BWEA Grid Code Representation

BWEA response to Grid Code Consultation H/04 and SA/2004 and Ofgem Regulatory Impact Assessment

Econnect Project No: 1294

4.1a Power Park Unit Reactive Power Envelope

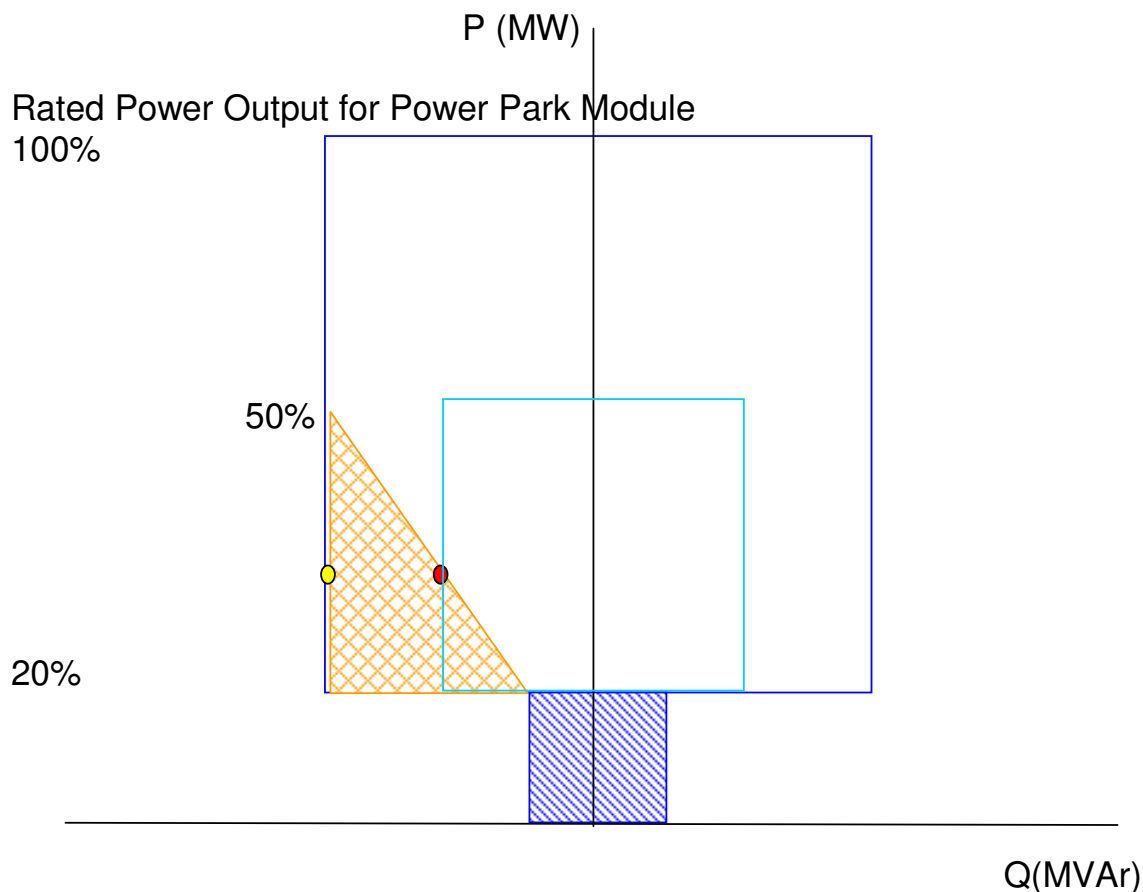
The amount of reactive power an asynchronous generator absorbs increases as its output power increases (as shown by the red characteristic in Figure 4.1a). Therefore additional capacitive compensation is required to allow reactive power to be exported from the wind farm onto the network, in order to comply with the reactive power requirement as defined in the proposed Grid Code changes. However, the shape of the proposed reactive power requirement characteristic (Figure 1 in CC6.3.2 (c)) also means that extra INDUCTIVE compensation may be required in order for the wind farm to be able to absorb the same amount of reactive power at 20% active power output as it does at 100% active power output. It is the BWEA's opinion that the cost of this extra reactive equipment is not justified by a system need. Hence the BWEA recommends that the proposed GB Grid Code reactive requirement characteristic be amended to account for the P/Q characteristic of the asynchronous generator between 20% and 50% of its active power output (as defined by the removal of the hatched triangle in Figure 4.1b). Such an amendment would bring the GB Grid Code into line with the reactive requirement in the ESB Grid Code in Ireland.

If this amended reactive requirement is extended to a power park module as a whole, it can be seen from Figure 4.1b that the same reactive power output is achieved for 100% of the Power Park Units (PPUs) operating at 25% of active power output, as for 50% of the PPUs operating at 50% of their active power output (indicated by the red dot).

The original reactive requirement characteristic however calls for 100% of the PPU's operating at 25% of their active power output to produce double the reactive output of the scenario where only 50% of the PPU's are operating at 50% of their active power output (indicated by the yellow dot). This methodology is inconsistent as it calls for different levels of reactive power output from the power park module for the same active power output.

The BWEA proposal will not therefore have any impact on investment costs as the transmission system operator would already have to design the network for the lower reactive power capabilities of the windfarm with some PPU's not operating.

- CC 6.3.2 (c) Figure 1 amended
- CC 6.3.2 (d) remove due to retrospective applications
- CC 6.3.2 (new d) new clause describing requirements below 20% of rated power

Figure 4.3a simplified windfarm single line diagram

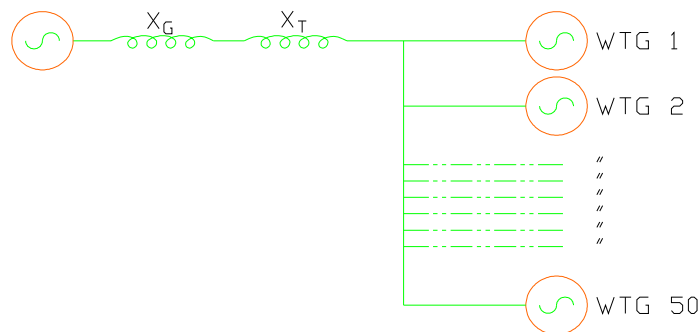
Figure 4.3a represents a windfarm of 50 turbines. The impedance X_g determines the fault level at the point of connection. The impedance X_t represents the grid transformer and the turbine transformers and is selected with a high enough value to provide sufficient retained voltage on the generator terminal in the event of a grid fault. However, the impedance X_t cannot be infinite due to costs, voltage regulation and the losses generated in the associated resistance. Figure 4.3b shows the effects of a grid fault with the whole windfarm operating

Figure 4.3b Grid Fault with all turbines operating

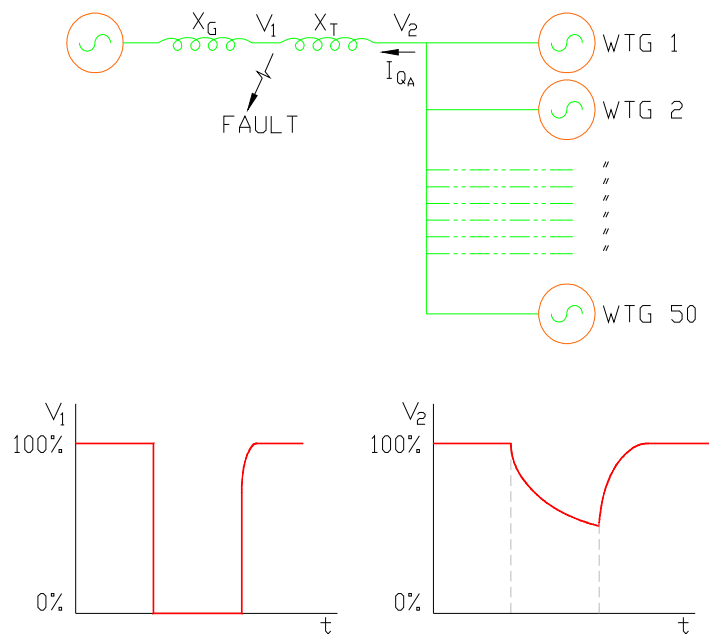
Figure 4.3b shows the voltage at the fault, V_1 , falling to zero for a short duration until the fault is cleared. The voltage at the generator terminals, V_2 , falls more slowly due to the reactive current I_{QA} supplied, for example, by the demagnetisation of the generators. In this example the voltage V_2 remains sufficiently high due to the impedance X_t and the fault current I_{QA} to allow the generators to ride through the fault.

Figure 4.3c Grid Fault with one turbine operating

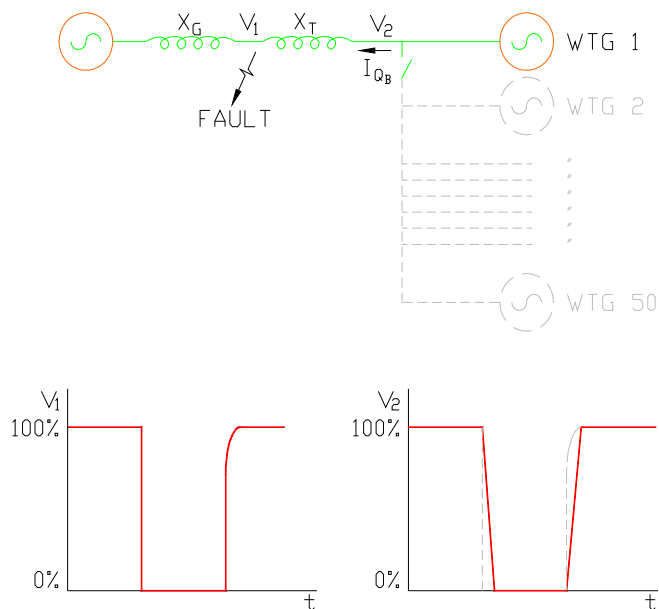
Figure 4.3c shows the impact when fewer turbines are connected during the fault and in this case only one turbine is connected. The voltage profile at the fault, V_1 , is effectively unchanged. However, the voltage at the generator terminals, V_2 , has now fallen (in this example to zero), as the reactive current I_{QB} is now $1/50^{\text{th}}$ of its previous value whereas the value of the impedance X_t is unchanged. The voltage V_2 is now no longer high enough to allow the generator to ride through the fault.

The example shown in Figures 4.3 demonstrates that a design limit for FRT is required. The number of generating units connected, and not the real power output of the windfarm determine this limit.

Removing the requirement for wind farms to ride through when less than 50% of the turbines are operating provides a design limit, which can generally be achieved without excessive additional costs.

The BWEA therefore supports the proposed wording in main consultation for Clause 6.3.15 (c) (i) and does not support Option 2.

Figure 1 (revised)

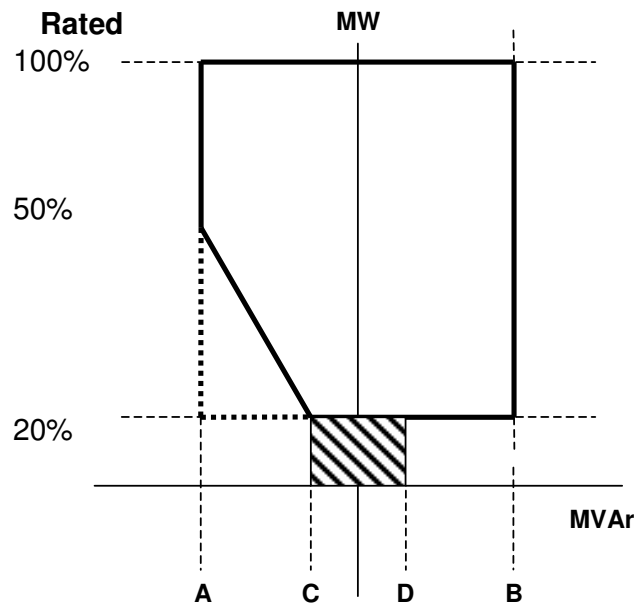
BWEA expects to see the same definitions applied to Scotland as England and Wales.

This clause is reinserted from NGC H/04 consultation June 2004 to cover the shaded area of figure 1.

- (c) Subject to the provisions of CC.6.3.2 (d) below, all **Non-Synchronous Generating Units, DC Converters** (excluding current source technology) and **Power Park Modules** (excluding those connected to the **Total System** by a current source **DC Converter**) with a **Completion Date** on or after 1 January 2006 must be capable of supplying **Rated MW** output at any point between the limits 0.95 **Power Factor** lagging and 0.95 **Power Factor** leading at the **Grid Entry Point** ~~in England and Wales or at the HV side of the 33/132kV or 33/275kV or 33/400kV transformer for Generators directly connected to the GB Transmission System in Scotland (GN1)~~ (or **User System Entry Point** if **Embedded**). With all **Plant** in service, the **Reactive Power** limits defined at **Rated MW** will apply at all **Active Power** output levels above 20% of the **Rated MW** output as defined in Figure 1. These **Reactive Power** limits will be reduced pro rata to the amount of **Plant** in service.

Point A is equivalent (in MVar) to: 0.95 leading **Power Factor** at **Rated MW** output
 Point B is equivalent (in MVar) to: 0.95 lagging **Power Factor** at **Rated MW** output
 Point C is equivalent (in MVar) to: -5% of **Rated MW** output
 Point D is equivalent (in MVar) to: +5% of **Rated MW** output

- (d) In the shaded area of Figure 1 the operation is at the discretion of the **Generator** or **DC Converter Station** owner.

Figure 5

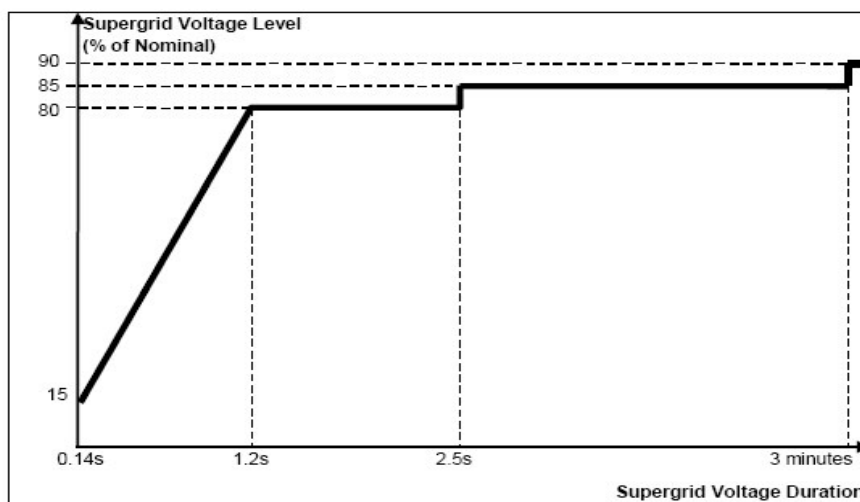
Option 4 Paragraph CC.6.3.15(b)(ii) and (iii)

- (ii) provide **Active Power** output, during **Supergrid Voltage** dips as described in Figure 5, at least in proportion to the retained balanced voltage at its Grid Entry Point Supergrid Voltage [GN2] (or the retained balanced voltage at the **User System Entry Point if Embedded**) and shall generate maximum reactive current without exceeding the transient rating limits of the **Generating Unit** or **Power Park Module** and any constituent element; and,

- (iii) restore **Active Power** output, at a minimum rate of 10% of Rated MW per second, following Supergrid Voltage dips as described in Figure 5, following within 1 second of restoration of the voltage at the Grid Entry Point Supergrid Voltage to the minimum levels specified in CC.6.1.4 (or within 1 second of following restoration of the voltage at the **User System Entry Point** to 90% of nominal or greater if **Embedded**), to at least 90% of the level available immediately before the occurrence of the dip except in the case of a **Non-Synchronous Generating Unit** or **Power Park Module** where there has been a reduction in the **Intermittent Power Source** in the time range in Figure 5 that restricts the **Active Power** output below this level.
